MEMORANDUM DATE: September 2, 2020

RE: **814 North Ocean Breeze**

TITLE: **HRPB Project Number 20-00100171:** Consideration of a Certificate of Appropriateness (COA) for roof replacement for the property located at **814 North Ocean Breeze**; PCN#38-43-44-21-15-232-0040. The subject property is a noncontributing resource to the Northeast Lucerne Local Historic District and is located within the Single-Family (SF-R) Zoning District.

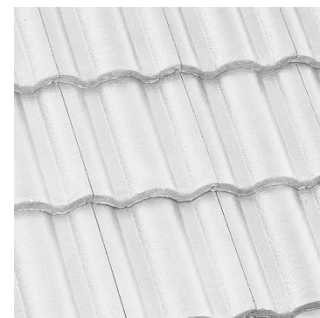
According to the Secretary of the Interior's Standards and the City of Lake Worth Beach Design Guidelines, distinctive materials that characterize a property shall be preserved, or replaced in-kind. If a distinctive feature must be replaced, the new feature should match the old in design, color, texture, and materials where possible. The roof material is an important character-defining feature of a historic property. Flat white concrete tiles that replicate historic tile profiles and dimensions are still in production today, and could be utilized as the replacement roofing material.

It is the analysis of Staff that the proposed change to a simulated barrel tile in terracotta could negatively affect the character-defining feature of the property. The Masonry Minimal Traditional style of architecture primarily used flat white concrete tiles as a roofing material, and occasionally used an asbestos shingle, asphalt shingle, or rolled roofing. The Historic Preservation Architectural Style Section for Minimal Traditional Structures is included as **Attachment C**. Utilizing concrete simulated barrel tiles in terracotta on a Masonry Minimal Traditional structure is a significant departure in profile, design, and color. Masonry residential structures throughout Lake Worth Beach were designed with an emphasis placed on horizontality. The buildings are typically linear in appearance, often one story, and utilized horizontal details in windows and doors. The roofing materials for these buildings continued this theme, with thick concrete tiles laid in horizontal rows creating a visually stepped appearance towards the high point of the roof. The proposed concrete tiles in terracotta have a profile, color, and design that replicates barrel tiles which are appropriate for Mission Revival and Mediterranean Revival structures.
